California High-Speed Train Project

Request for Proposal for Design-Build Services

RFP No.: HSR 11-16
Design Variance Report

06/29/2012 ADDENDUM 3 - RFP HSR 11-16

CONTRACT NO.
DRAWING NO. TT-D3006
SCALE AS SHOWN
SHEET NO.

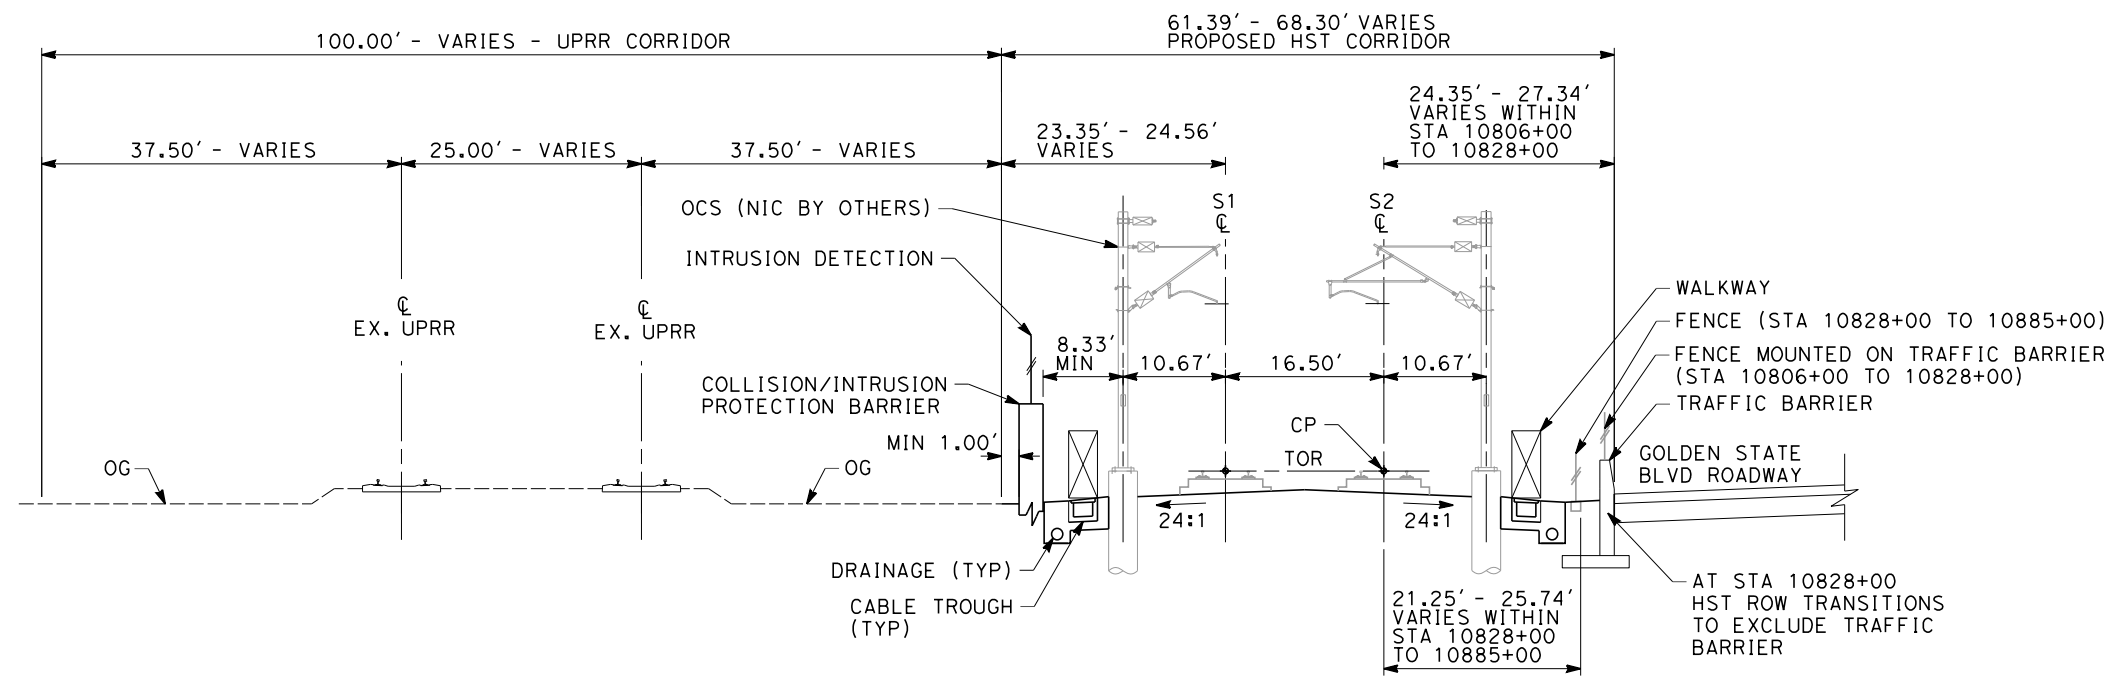
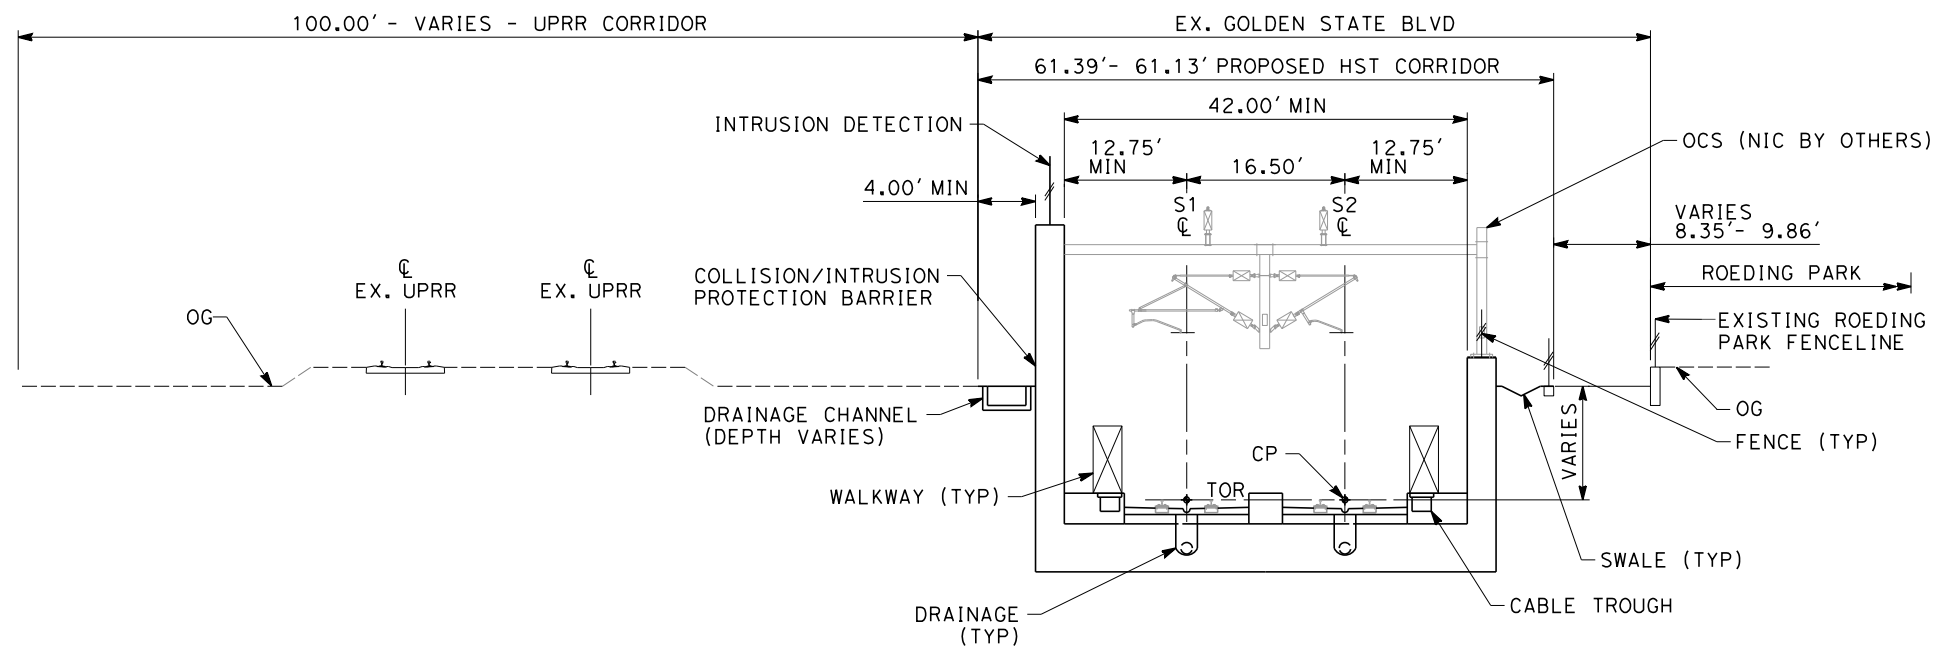
CHSTP DESIGN REQUIREMENT Include reference to drawings, design criteria, technical memos, specifications	Memo dated 8/30/2010 – Clearances to conventional railroads, Union Pacific Railroad (UPRR) right-of-way (ROW), high-speed train (HST) bridge piers, and highways – TM reference number not available
DESIGN CRITERIA REQUIRING A VARIANCE	<p>Memo dated 8/30/2010 – Clearances to conventional railroads, UPRR ROW, HST bridge piers, and highways (hereafter referred to as “The Memo”).</p> <p>Drawing 1 – HSR in shared corridor with UPRR at grade, in The Memo requires a minimum 12-foot separation between edge of UPRR ROW and face of derailment containment barrier. An extract is shown in Appendix A.</p>
REASON FOR REQUESTING A VARIANCE	<p>The constraints of State Route 99 and Roeding Park limit the corridor width available to HST.</p> <p>Between W Olive Avenue and E Belmont Avenue the HST corridor would be constrained by UPRR on the east and Roeding Park on the west. This location currently contains Golden State Boulevard which would be replaced with the HST corridor. Roeding Park is a Section 4(f) property and is not to be impacted by the footprint of the HST works. The available width between the UPRR ROW and Roeding Park boundary is 70ft. The available width does not allow for a 60-foot wide HST corridor with a 12-foot separation to the UPRR ROW. Achieving the 12-foot separation to UPRR ROW would require either intrusion into Roeding Park or the UPRR ROW, or a substandard HST ROW width. A layout of the design is shown in Appendix B.</p>

JUSTIFICATION FOR VARIANCE	<p>Roeding Park is a Section 4(f) property and is not to be impacted by the footprint of the HST works. The available width between the UPRR ROW and Roeding Park boundary is 70ft. The available width does not allow for a 60-foot wide HST corridor with a 12-foot separation to the UPRR ROW. Achieving the 12-foot separation to UPRR would require either intrusion into Roeding Park or the UPRR ROW, or a substandard HST ROW width.</p> <p>A substandard HST ROW was dismissed due to the construction complexity already required in this area. Adjacent to Roeding Park the HST would be in a trench and would already require a complex construction sequence to achieve the works within 60-foot HST corridor.</p> <p>The proposed configuration is consistent with the approach set out in TM 1.1.21 – Typical Cross-Sections for 15% Design. Drawing number C0303 identifies the HST ROW adjacent to a freight ROW in a shared corridor. Drawing 1 in The Memo also identifies HST ROW adjacent to a freight ROW for any freight carrier that is not UPRR. Therefore it is understood that locating the HST ROW adjacent to the</p>

<p>UPRR ROW, with an intrusion protection barrier, does not constitute a safety risk beyond the scenarios identified in the above standards.</p> <p>The proposed cross-section of the HST corridor (Appendix B) meets the intrusion protection criteria in Draft TM 2.1.7 Rev 1 dated 21 July 2011.</p> <p>As part of the proposed design a 96-inch storm drain would require relocating. One of the options for rerouting the storm drain is to construct it between the HST alignment and Roeding Park. Increasing the separation between the UPRR and HST in this area would prohibit this storm drain realignment option.</p> <p>North of Clinton Avenue the alignment must tie in to the Merced to Fresno team alignment, which is constrained by State Route 99.</p>
PROPOSED ALTERNATIVE DESIGN REQUIREMENT	Due to the constraints identified a design variance is requested for the separation criteria between HST and UPRR corridors.

CONTRACT NO.
DRAWING NO. UT-C4041
SCALE AS SHOWN
SHEET NO.

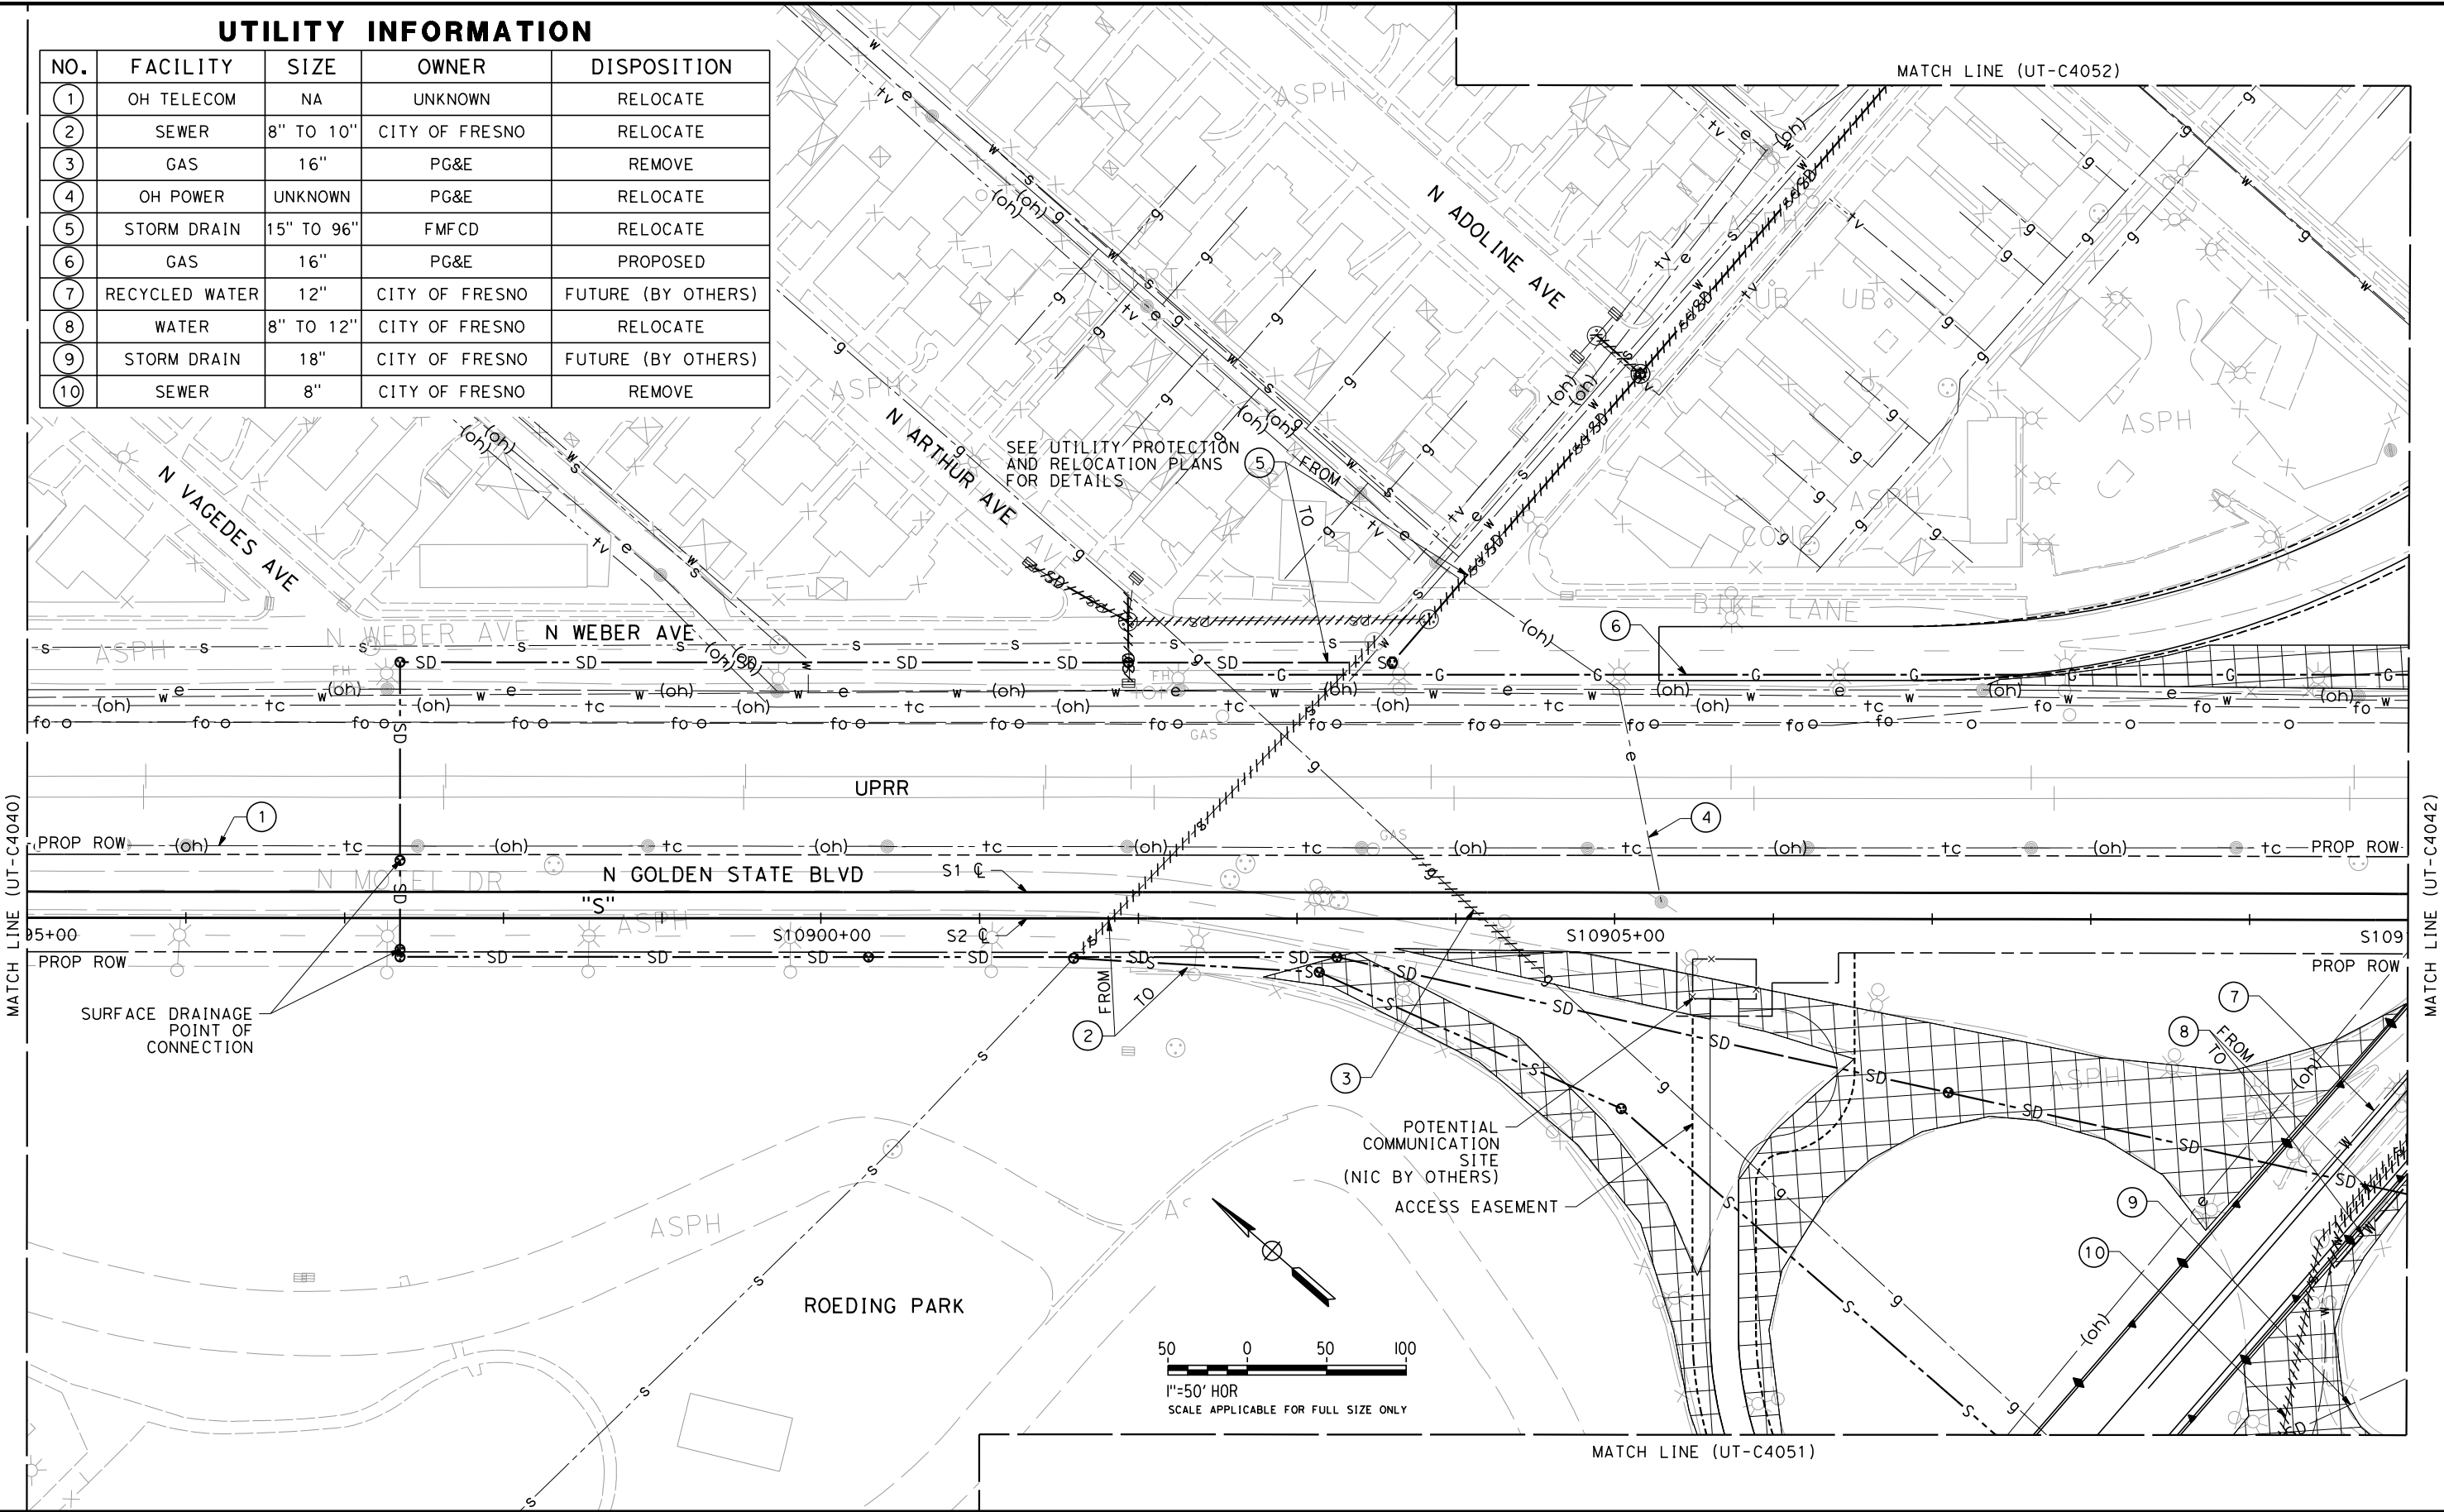
Appendix C – Potential Storm Drain Relocation
